## Product Change Notice (PCN)

**PCN Number:** PCN-0451321R-01

**Product(s) Affected:** PDP-40

### Old Design

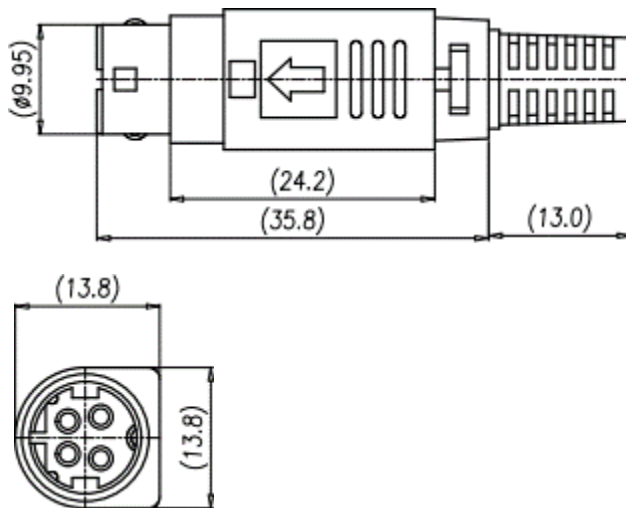
**Reason(s) for Change:** manufacturing build location change.

**Description of Change:** housing and materials changes as shown below.

MATERIAL	PLATING
OUTER HOOD	ABS	
METAL SLEEVE	Brass	Nickel
CLAMP	Brass	Nickel
PIN/BODY	Brass/PBT	Silver
PLASTIC RING	POM	
METAL COVER	Brass	Nickel
SPRING	Steel	
INNER HOOD	ABS	
STRAIN RELIEF	PVC

MATERIAL	PLATING
housing	PBT (UL94V-0)	
contacts	copper alloy	silver
plastic cover	ABS	
metal shell	copper alloy	nickel
metal cap	copper alloy	nickel
cable fixer	copper alloy	tin
ring	POM	
spring	steel	nickel
plastic tube	ABS	
SR	PVC
